Job ID: 2012-05-3904-HVAC

has permission to Replace existing air handler system with new Trane system, energy upgrades at Luther Bonney Hall provided that the person or persons, firm or corporation accepting this permit shall comply with all of the provisions of the Statues of Maine and of the Ordinances of the City of Portland regulating the construction, maintenance and use of the buildings and structures, and of the application on file in the department.

LUTHER BONNEY ENERGY UPGRADES ADDENDUM #1 MARCH 15, 2012

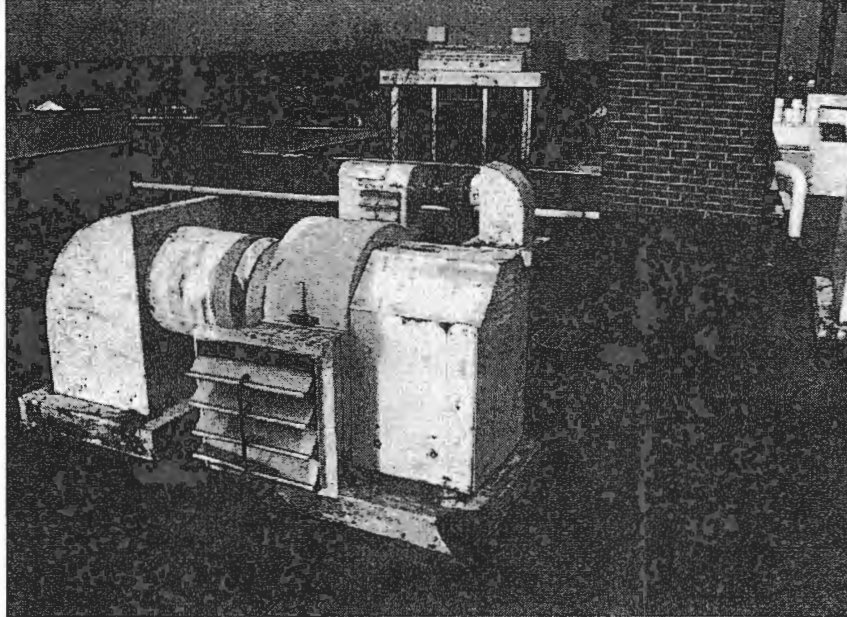
10. In the Specification Section 230700 3.15C, insulation is listed for Refrigerant Suction and Hot-Gas Piping, should this be Suction piping only?
 - Yes. See the updated Specification; Hot-Gas Piping has been removed.
11. There is no Specification section provided for the Air Cooled Condensing Units. Will one be provide?
 - Yes. See the updated Specification with the addition of Sections 236313 and 232300.
12. Picture of the Classroom Tower roof to estimate exhaust fan curbs.
